AGENDA MEMORANDUM

To: Design Review Board

Title: **THE SOUTH 10.00 FEET OF LOT 2 AND ALL OF LOT 3, BLOCK 12, TOWN OF CASTLE ROCK, COUNTY OF DOUGLAS, STATE OF COLORADO AND THE NORTH 49.84 FEET OF LOT 4, BLOCK 12, TOWN OF CASTLE ROCK, COUNTY OF DOUGLAS, STATE OF COLORADO, Site Development Plan**
["City Hotel", 415 North Perry Street]

Figure 6: Footprint 2010

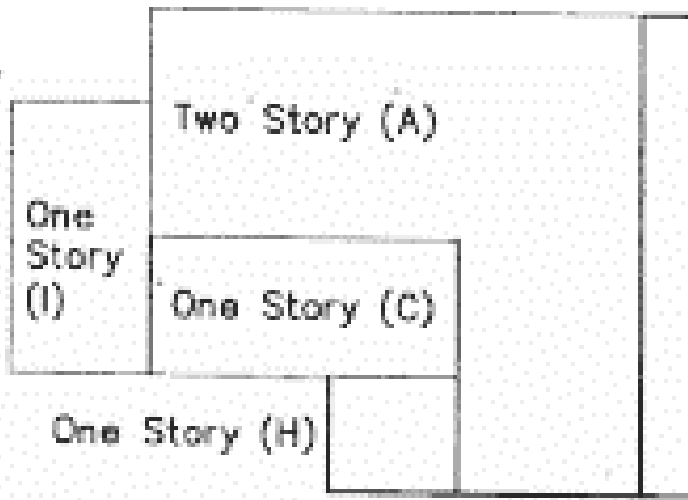
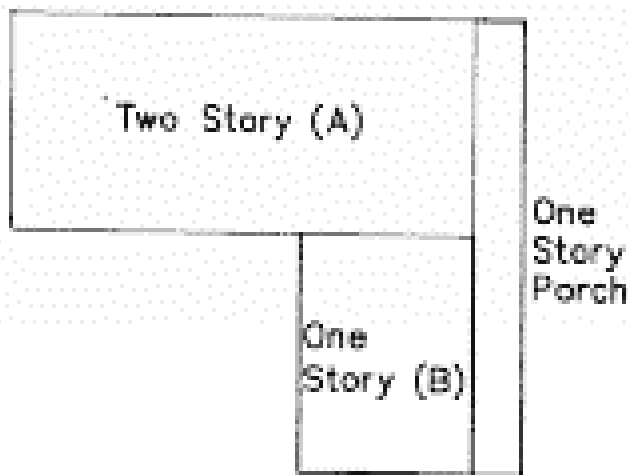
- Removal of Additions – The applicant proposes to remove the additions labeled as C, H, and I on the below footprint diagram.

The Additions H and I were added to the property sometime after 1949. The age of Addition C is unclear as the footprint of the addition was documented to change several times over the years. It is unclear if new additions were built or the original addition was modified. The proposed foot print of the City Hotel would resemble the footprint that was documented between 1874 and 1889 as shown below.
